Access Compliance Report

Public Rights-of-Way

(Curb Ramps)

Intersection ID: 10036289	Main Street: ROSE_RIDGE_PL	Cross Street: N/A	Location: SW
ADA ID: DE371B71627A	Ramp Type: Perp	Initial Pass/Fail: Fail	Overall Compliance: No
Codes/Mitigation Info/Possible Solution		Field Measurements/Component Compliance	
Severity Score: 25

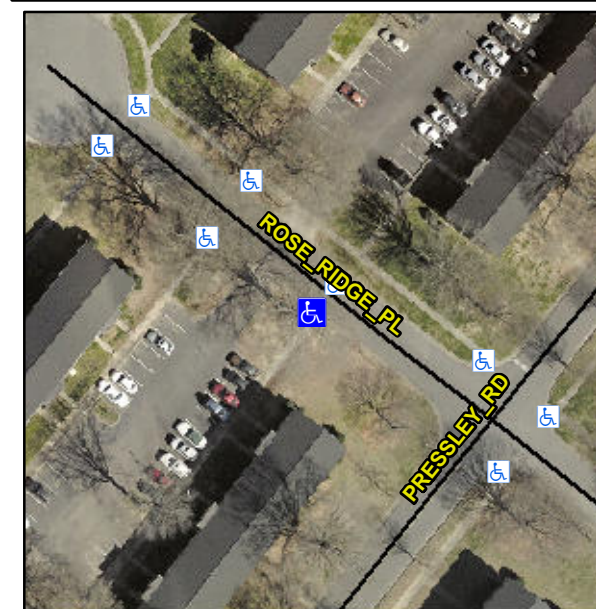
Not Found, R304.2.2

Compliance	Description	Data	Compliance	Description	Data
N/A	Ramp Length (in)	66.0	No	Ramp Slope (%)	17.8
Yes	Ramp Width (in)	48.0	Yes	Ramp XSlope (%)	0.5
N/A	Flare Type LT	N/A	N/A	Flare Type RT	N/A
N/A	Flare Slope LT (%)	N/A	N/A	Flare Slope RT (%)	N/A
N/A	Flare Traversable LT?	N/A	N/A	Flare Traversable RT?	N/A
N/A	Landing Length (in)	N/A	N/A	DWS Provided?	N/A
N/A	Landing Width (in)	N/A	N/A	DWS Contrast?	N/A
N/A	Landing Slope (%)	N/A	N/A	DWS Length (in)	N/A
N/A	Landing X Slope (%)	N/A	N/A	DWS Full Width?	N/A
N/A	Landing Curb? (Y/N)	N/A	N/A	DWS Offset (in)	N/A
N/A	Shared Landing?	N/A			
N/A	Gutter Ponding?	N/A	N/A	Gutter Slope (%)	N/A
N/A	Gutter Lip Ht (in)	1.5	N/A	Gutter X Slope (%)	N/A
N/A	Painted X Walk1?	No	N/A	Painted X Walk2?	N/A
	X Walk 1 Direction	To NE		X Walk 2 Direction	N/A
N/A	X Walk 1 Width (in)	N/A	N/A	X Walk 2 Width (in)	N/A
	X Walk 1 Slope (%)	2.9		X Walk 2 Slope (%)	N/A
	X Walk 1 X Slope (%)	2.6		X Walk 2 X Slope (%)	N/A

Remove & Replace Entire Ramp.
